**Consensus Recommendations
to Improve Protocols 2 and 3 for Defining Stream Restoration Pollutant
Removal Credits**

October 27, 2020

Prepared by:
David Wood and Tom Schueler, Chesapeake Stormwater Network

Figure 2. Floodplain Restoration by Raising the Stream Bed (Courtesy: Joe Berg, Biohabitats)

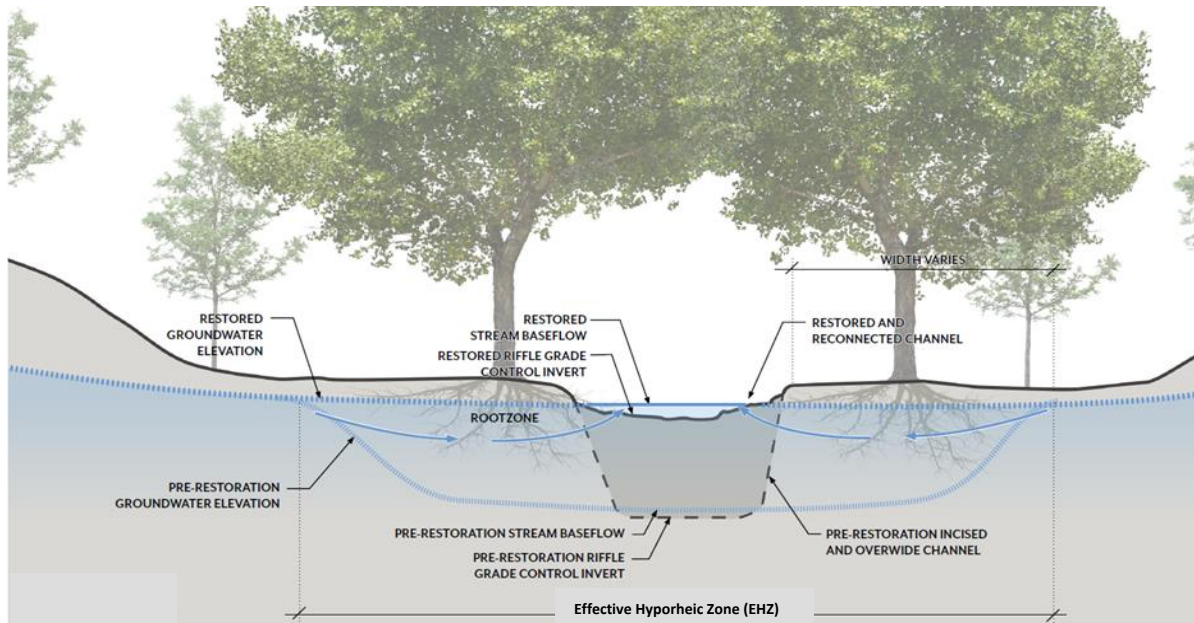
In addition, Figures 2 and 3 do not clearly illustrate these differences. Labels that reflect the narrative descriptions, including the 18 inch criteria, would provide greater understanding.

4. **Figure 2** is a poor sketch because it's not clear or well labeled.

Figure 3. Depiction of EHZ boundaries cross-section and plan view

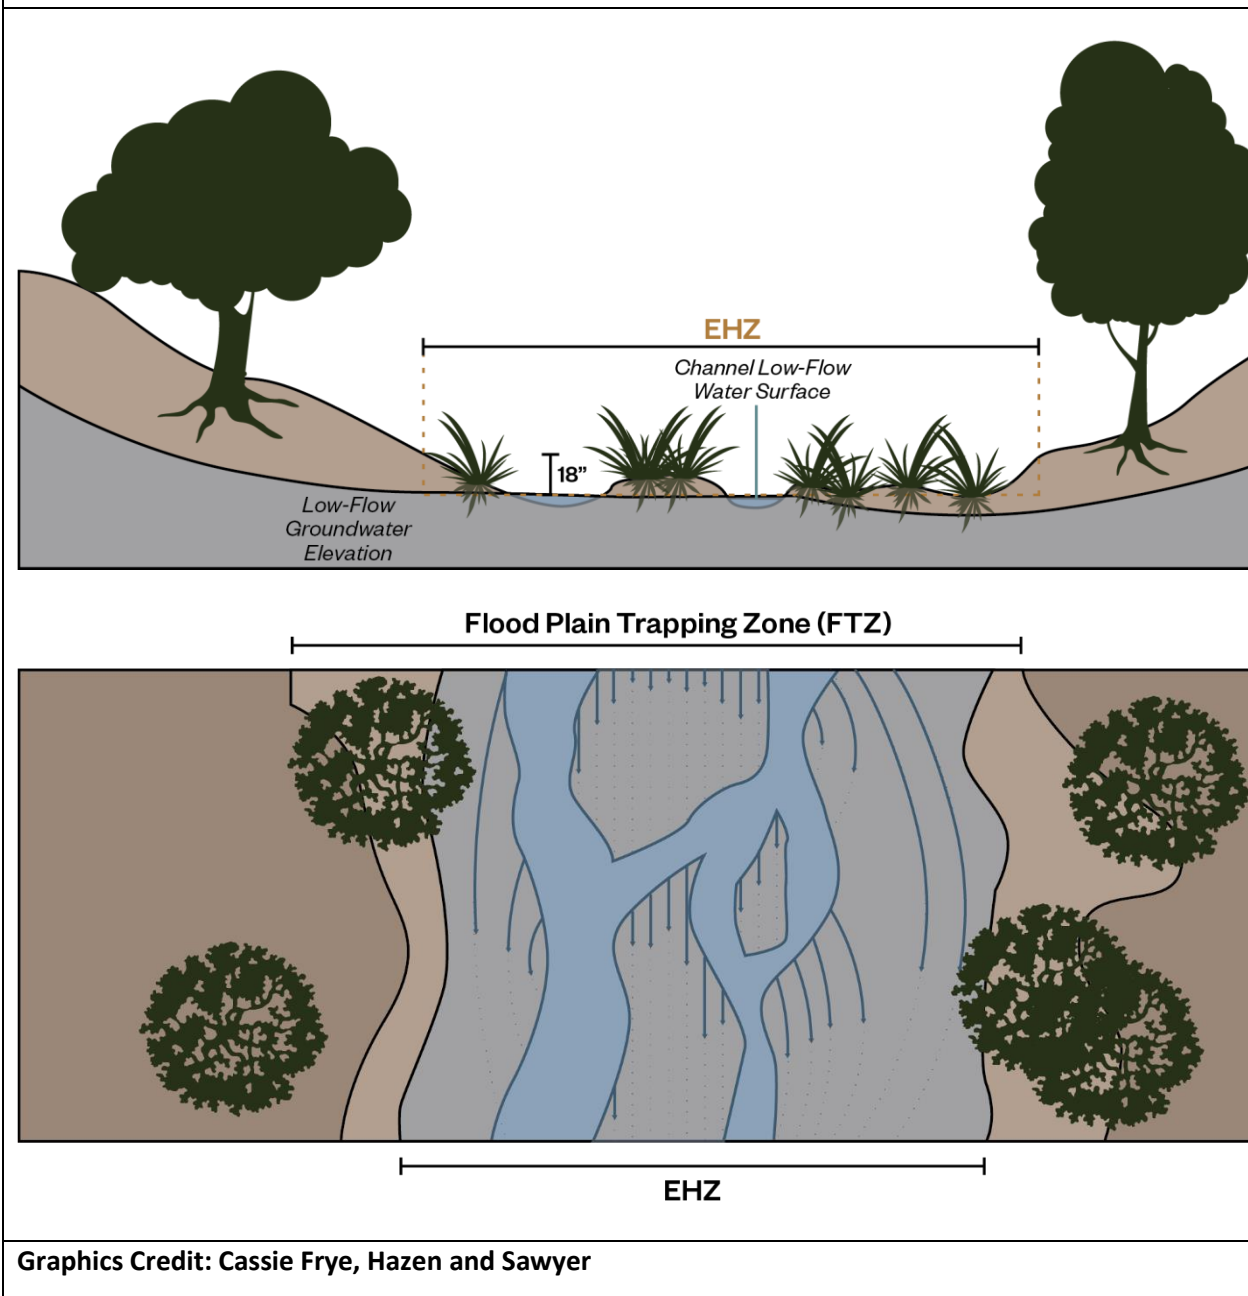
17. In Figure 3, please consider using a detail that does not have the name of a specific practitioner. This affords the specific practitioner a competitive advantage as the Department will be referring our stakeholders to this document.

2. The definition of the HEZ and EHZ needs further clarification both in the narrative and Figure 3 and how it applies to RSB projects. Please see Figure 3 for further details.

Response: This change has been made.

Figure 4. Illustration of site-specific discount factors for Protocol 2 (Courtesy: Jeff Hartranft, PA DEP; and Art Parola, University of Louisville).

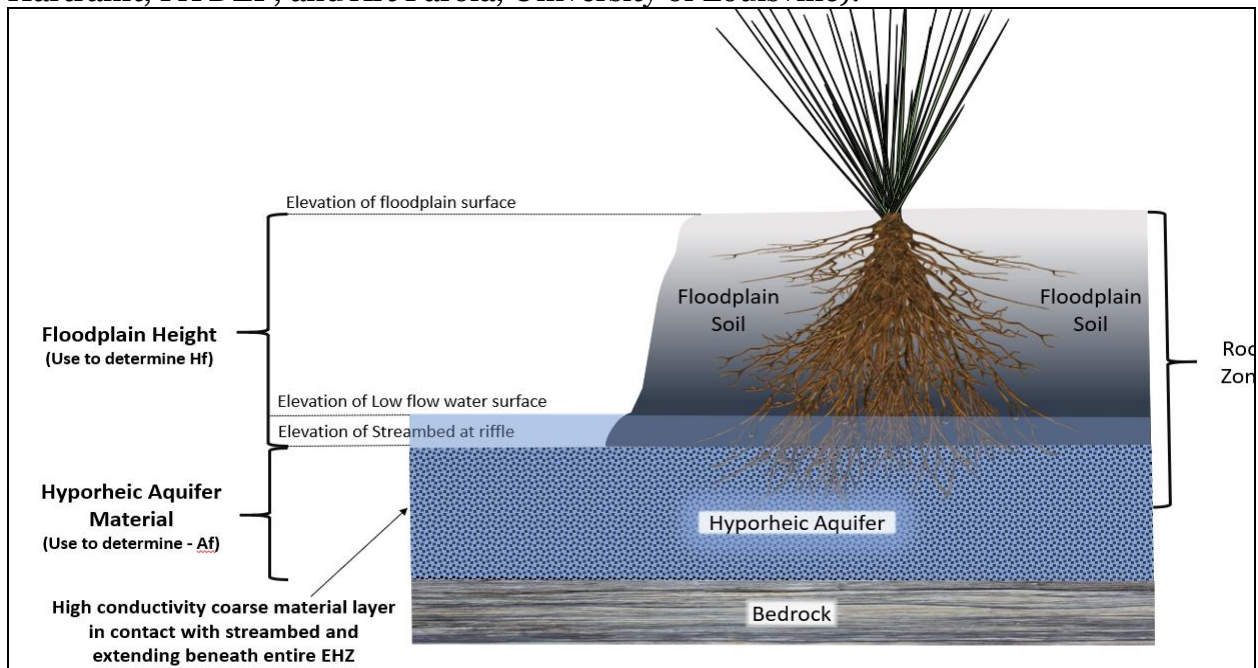
8. Pages 21 and 22: Figures 2, 3 and 4 seem very important yet are not easy to read. Figure 2 is a hybrid of LSR and RSB and contains EHZ and FTZ, but only for LSR, RSB uses old terminology of HB for some reason. Figures 3 has HEZ and EHZ but Figure 4 only specifically labels HEZ. The Text says that EHZ and FTZ are expressed

in Figures 2 and 4 but there's no FTZ in figure 4. Would it be useful to have same type of figure style for both plan view and section view and accurately refer to terms contained in figures in text? In addition, FTZ is only discussed in Protocol 3 - best to have a few robust, complete diagrams to which the two "Protocol" sections refer if possible.
